**DOCUMENT APPROVED  
 FOR OPERATING DEWATER MAINTENANCE PROJECT**  
 Division of Waste Management  
 Solid Waste Section  
 Received Dated: **July 2012 and revised through October 2012**  
 Date: **October 23, 2012** By: **Ming-Tai Chao**

**Re: Construction Record – 2011/2012 Dewatering Maintenance Project  
 Wilson County Municipal Solid Waste Landfill (MSWLF)  
 NC Solid Permit No. 98-01**

RE: **Response to Comments**  
**2011-2012 Dewatering Maintenance Project**  
**Wilson County MSWLF**

An As-Built Drawing of  
**WILSON COUNTY LANDFILL**  
**GAS COLLECTION SYSTEM**  
**DEWATERING MODIFICATIONS**  
Wilson County, North Carolina

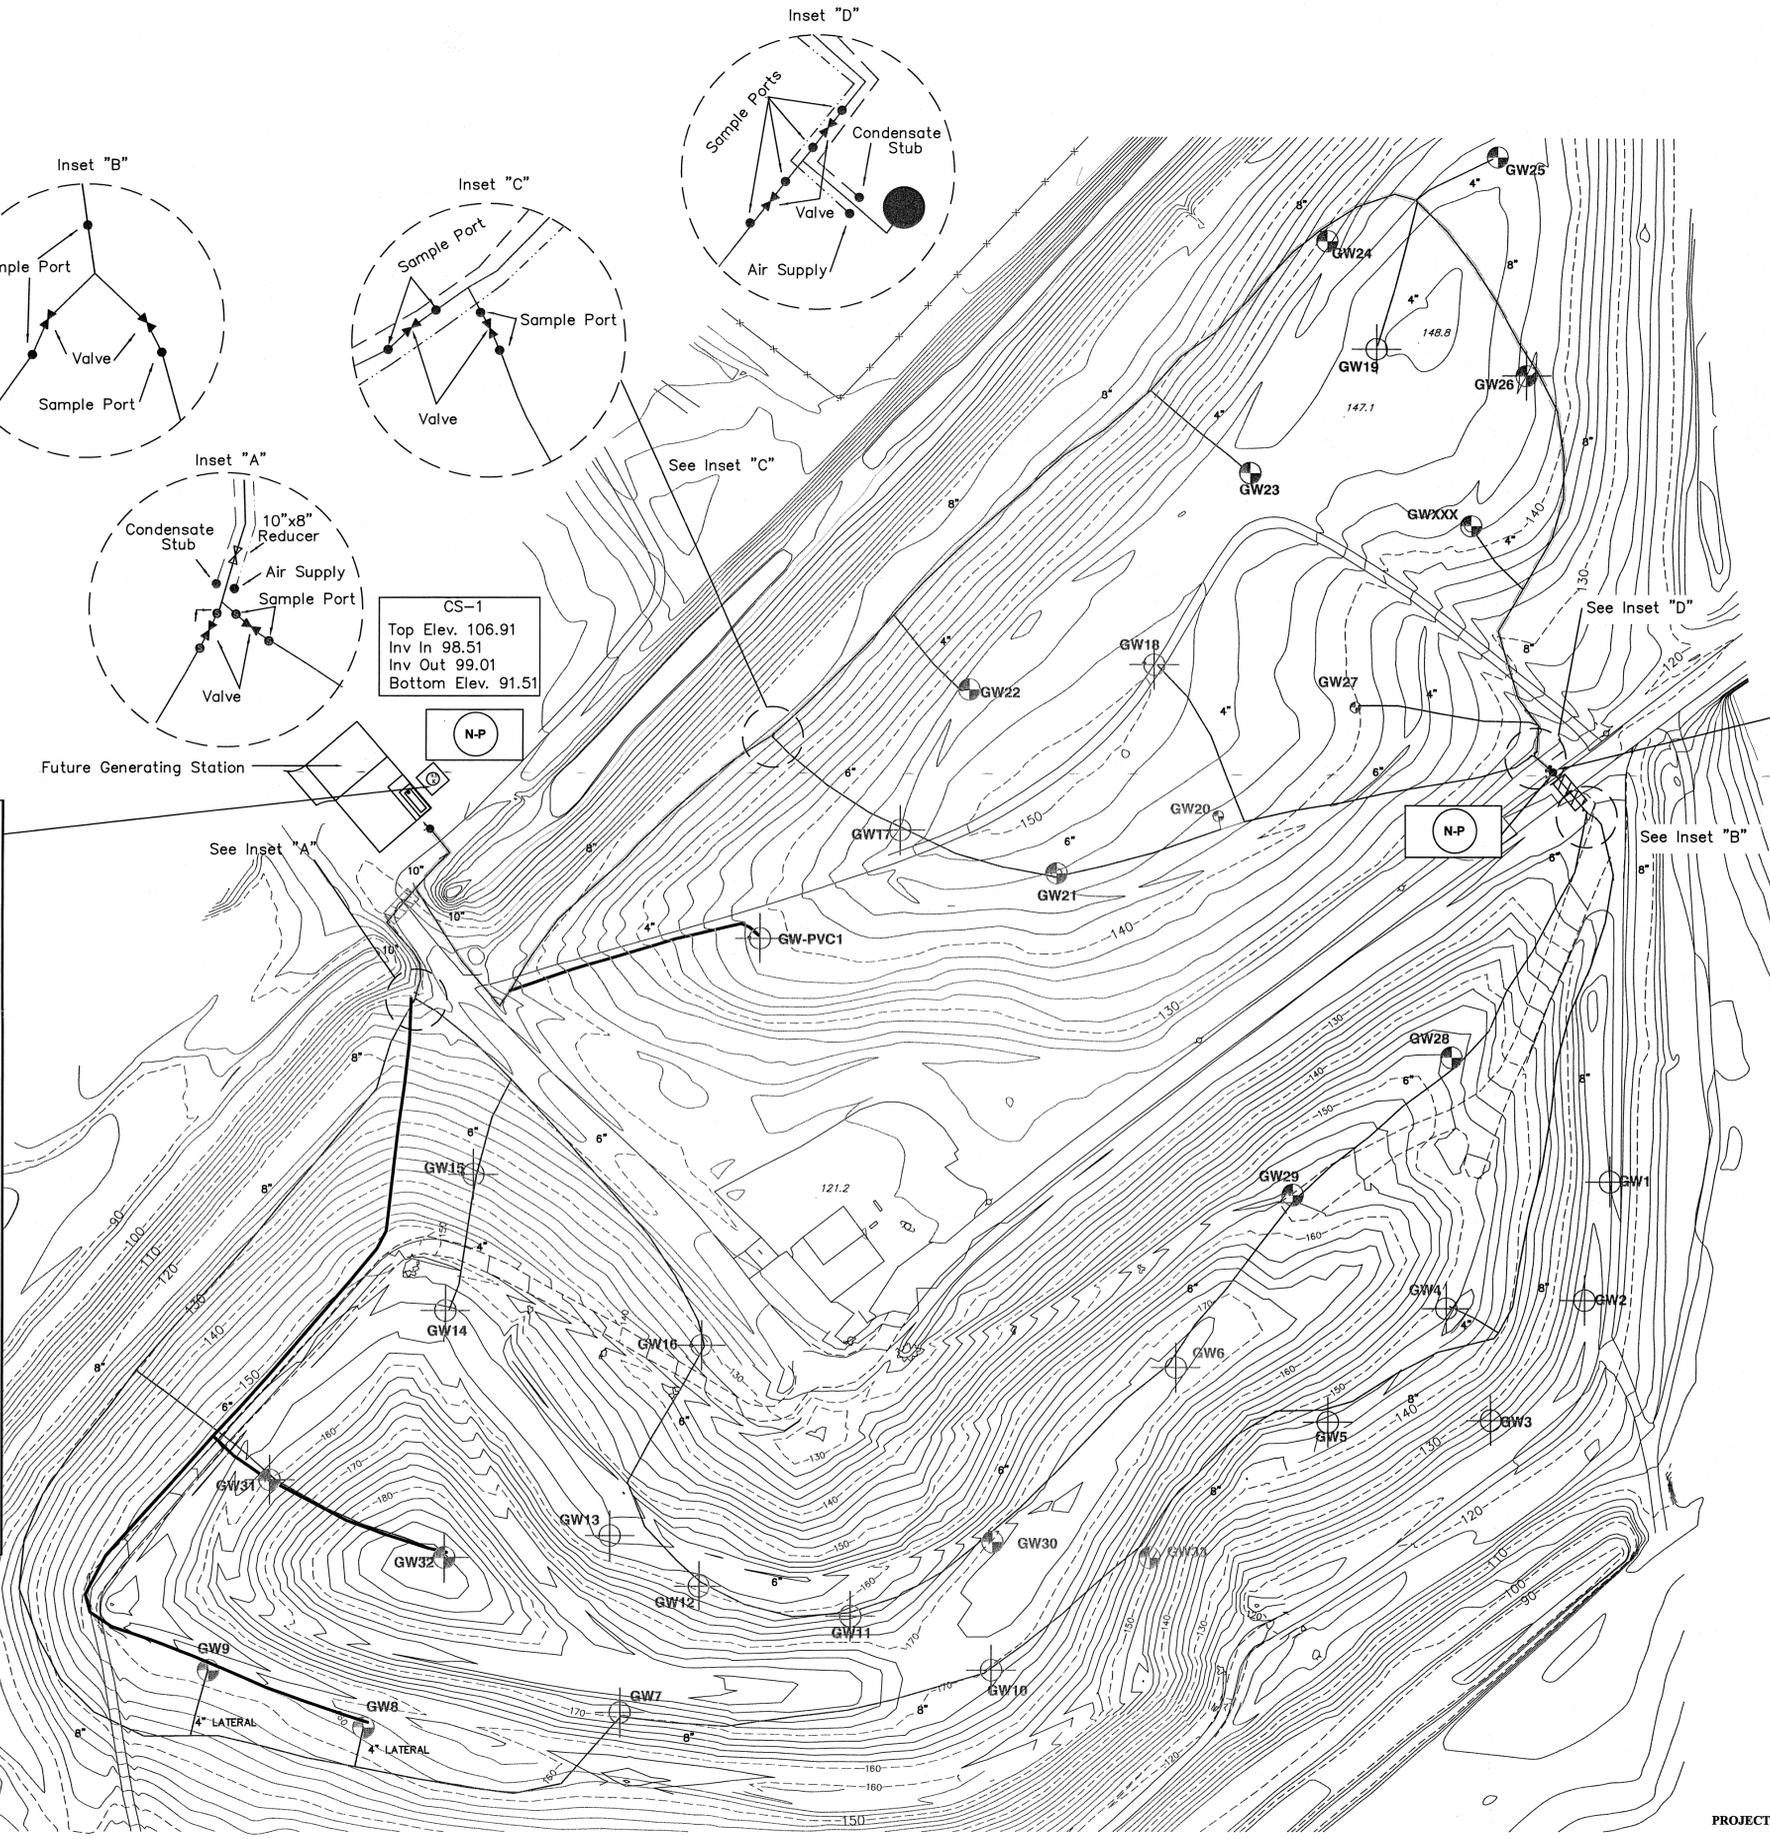
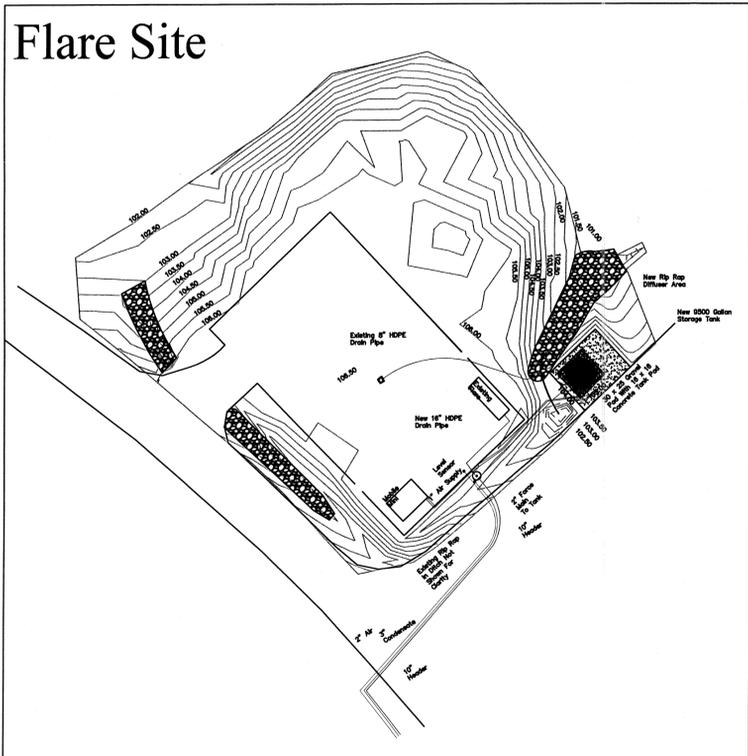
1. The Construction Record (on page 1) didn't describe the status of the two pumps which originally planned to be installed into wells GW-31 & GW-32 according to the approved "Dewatering Maintenance Operation Plan" dated September 2011 (Doc ID 15082). The As-Built Survey/Record Drawing (Sheet 3 of 6) in Attachment B indicated that pumps have been installed into the wells GW-31 & GW-32. Please describe the status of the two pumps associated with wells GW-31 & GW-32; or if there is any deviation from the original plan, please provide the causes resulted in this deviation. If the proposal of installing two pumps had been removed from the original plan during the course of the project, please revise the drawing (Sheet 3 of 6) accordingly.

- iv. Please describe the routine inspection of the AST [Rule.1680(c)(5)].
  - v. Please describe the closure of the AST [Rule .1680(f)].
4. The As-Built Survey/Record Drawing (Sheet 3 of 6) in Attachment B of the Construction Record must be signed, sealed and dated by a Professional Engineer registered in the State of North Carolina or a NC licensed surveyor.

5. According to the photo (on Page 2 in Attachment D) the identification numbers of the well GW-9 has been changed into EW-9. Has the change been done at all gas wells or just at the selected gas wells which involve to the Dewatering Project? Please clarify. To avoid any confusion in the future, please describe the variation of well identifications and revise the as-built drawing accordingly.

**Pumps were not installed in wells GW-31 and GW-32. They were removed from the original plan once it became evident that the pumps installed in GW-8 and GW-9 were causing moderate drawdown of the water levels in GW-31 and GW-32. A revised Record Drawing attached to this letter reflects this change.**

Please find attached the revised Record Drawing that has been signed, sealed, and dated by a NC licensed surveyor.

Temporary well identification numbers were used during construction and were not removed from the wells prior to taking the project completion photographs. The facility has relabeled each well so that they correspond to the identification numbers shown on the Record Drawing.

AS-BUILT SYSTEM DEWATERING MODIFICATIONS:
WILSON COUNTY LANDFILL, NC
1" = 100'
February 2012
3 OF 6

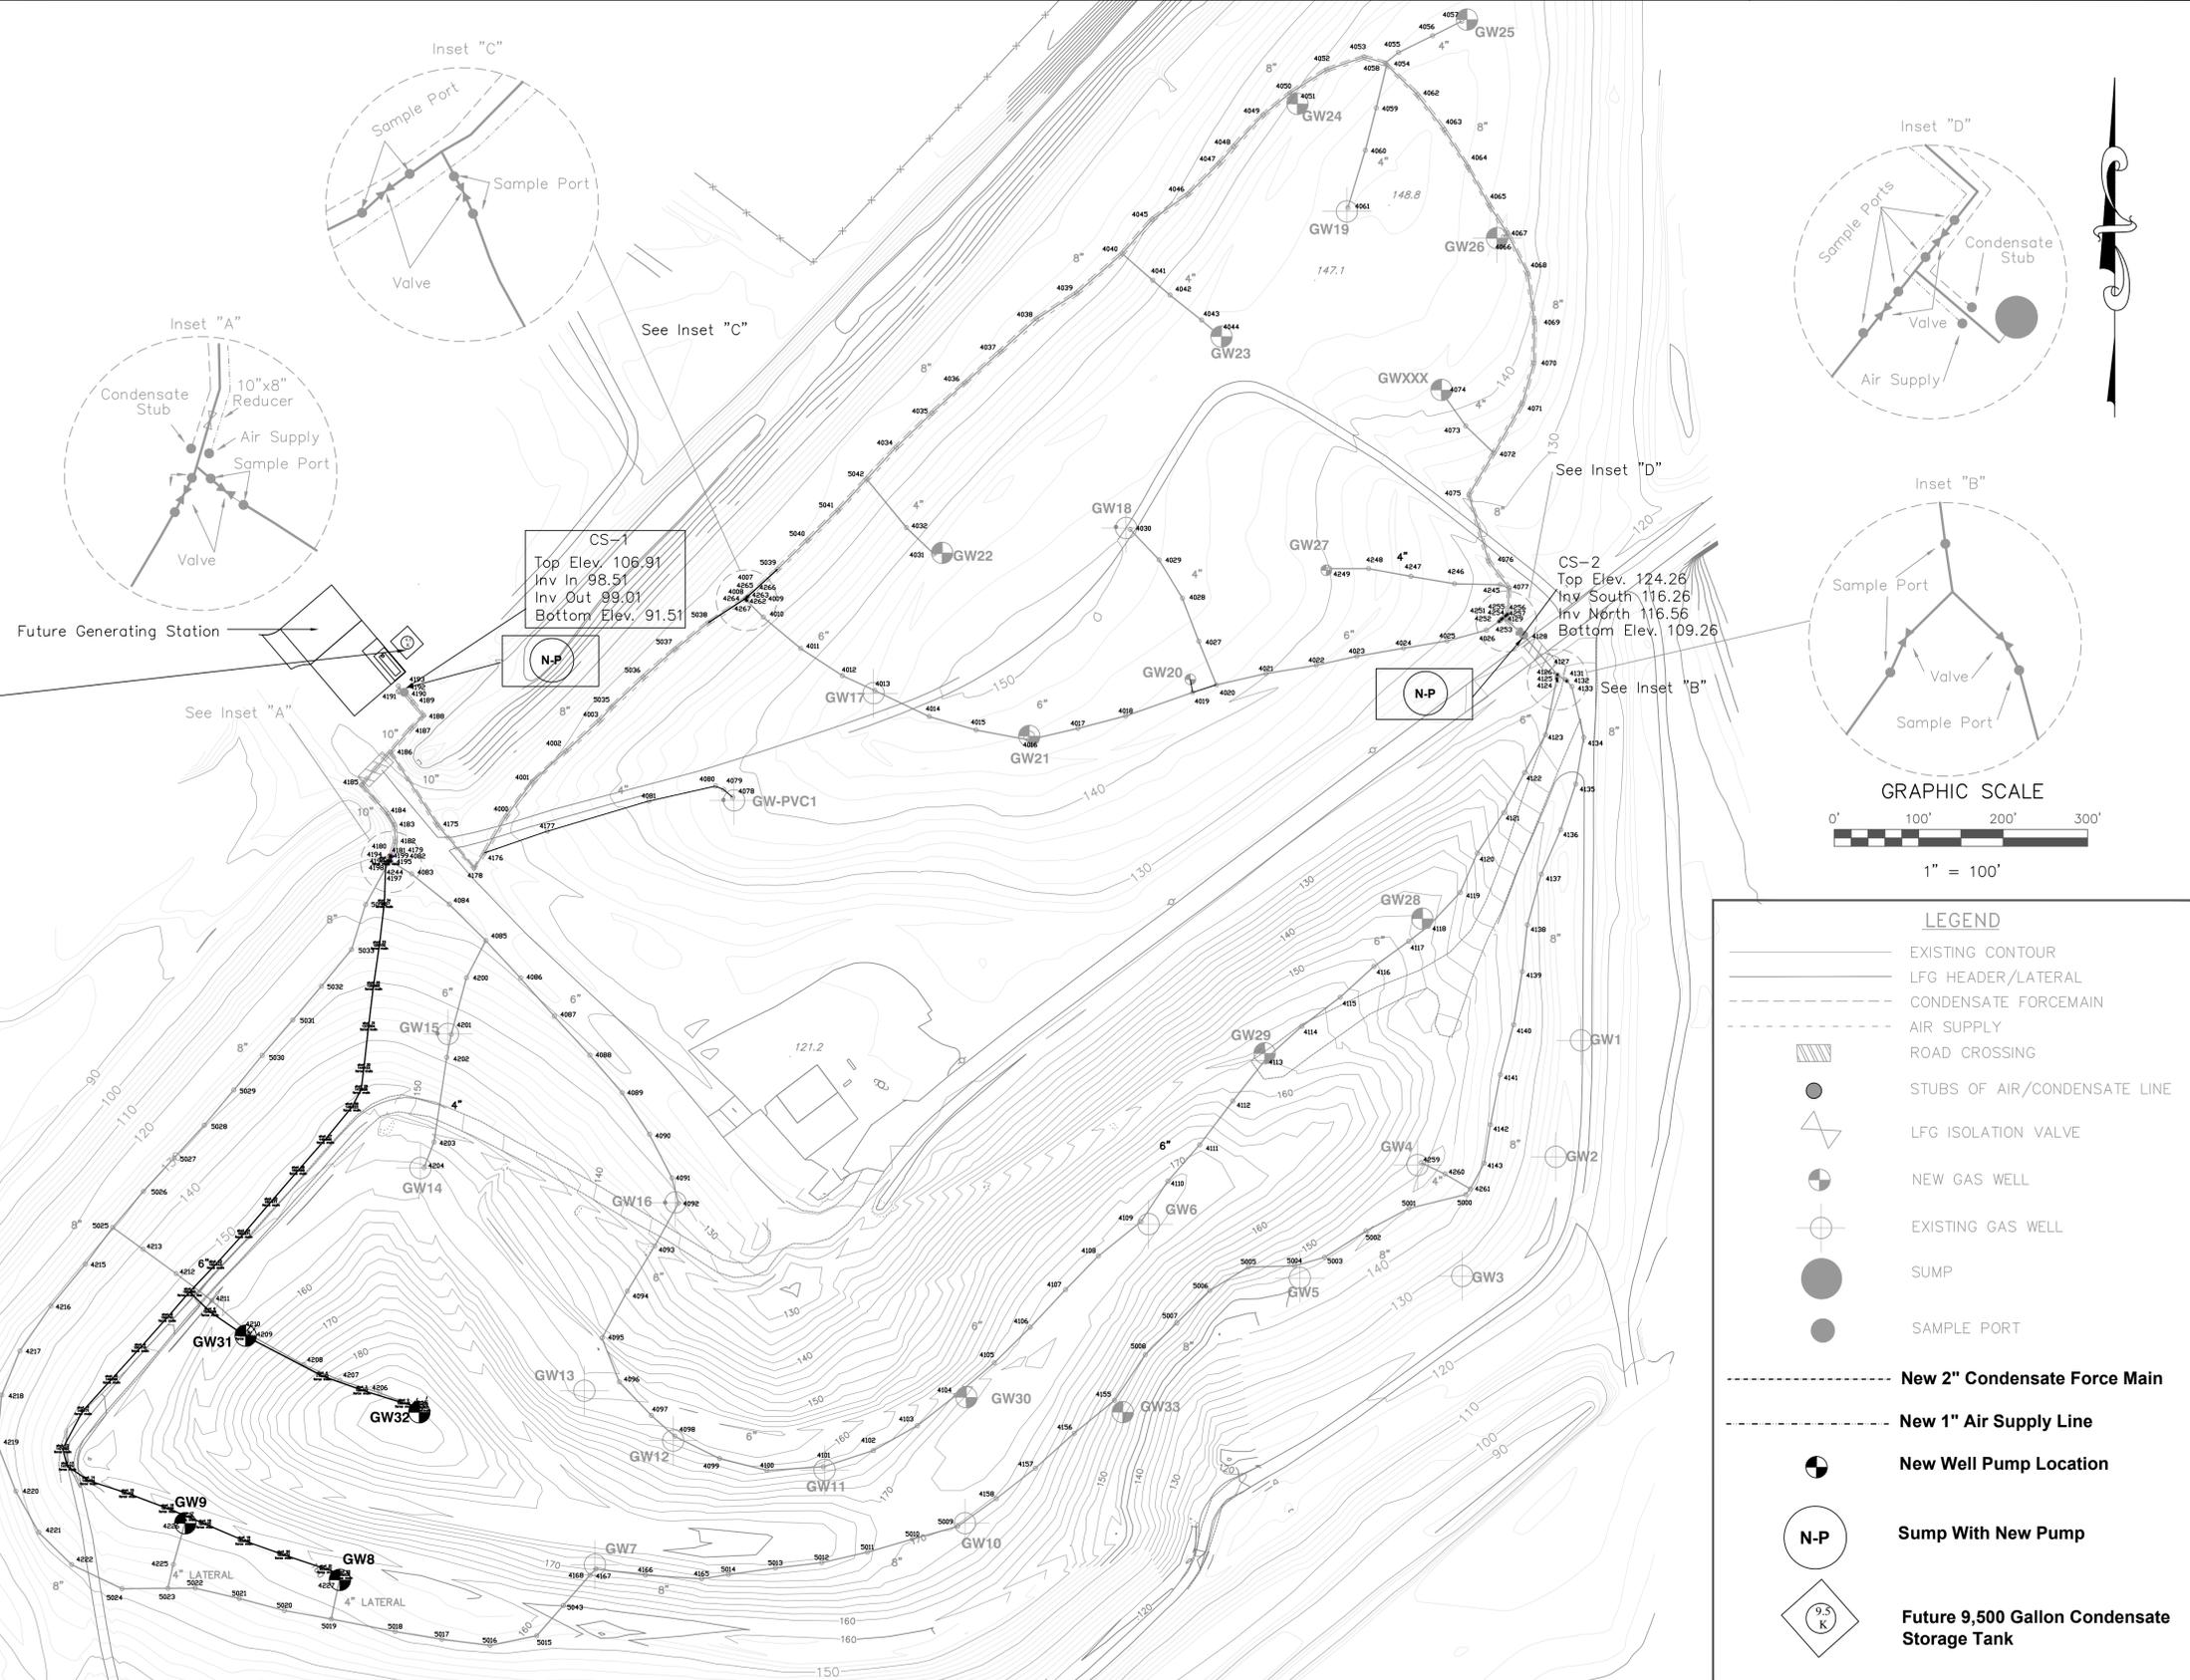
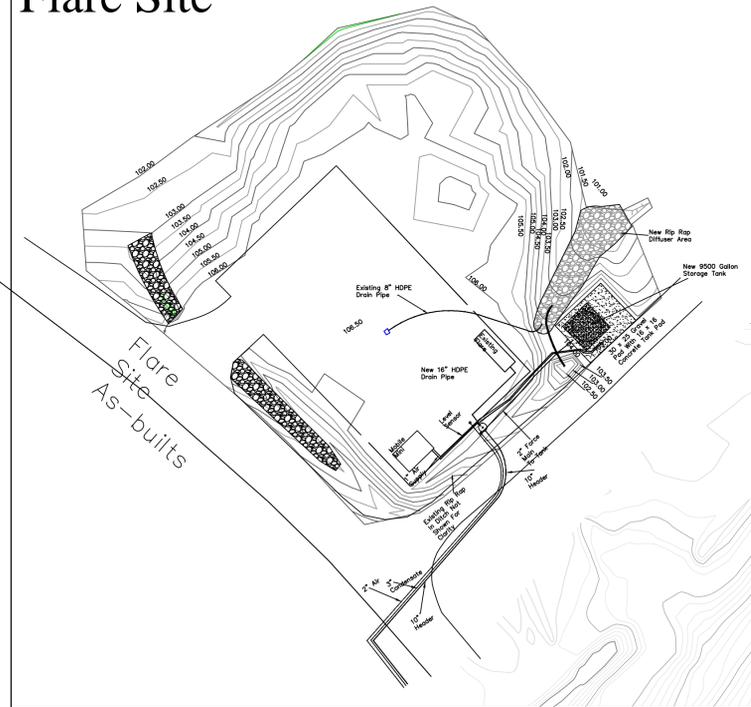
1. The Construction Record (on page 1) didn't describe the status of the two pumps which originally planned to be installed into wells GW-31 & GW-32 according to the approved "Dewatering Maintenance Operation Plan" dated September 2011 (Doc ID 15082). The As-Built Survey/Record Drawing (Sheet 3 of 6) in Attachment B indicated that pumps have been installed into the wells GW-31 & GW-32. Please describe the status of the two pumps associated with wells GW-31 & GW-32; or if there is any deviation from the original plan, please provide the causes resulted in this deviation. If the proposal of installing two pumps had been removed from the original plan during the course of the project, please revise the drawing (Sheet 3 of 6) accordingly.

4. The As-Built Survey/Record Drawing (Sheet 3 of 6) in Attachment B of the Construction Record must be signed, sealed and dated by a Professional Engineer registered in the State of North Carolina or a NC licensed surveyor.

5. According to the photo (on Page 2 in Attachment D) the identification numbers of the well GW-9 has been changed into EW-9. Has the change been done at all gas wells or just at the selected gas wells which involve to the Dewatering Project? Please clarify. To avoid any confusion in the future, please describe the variation of well identifications and revise the as-built drawing accordingly.
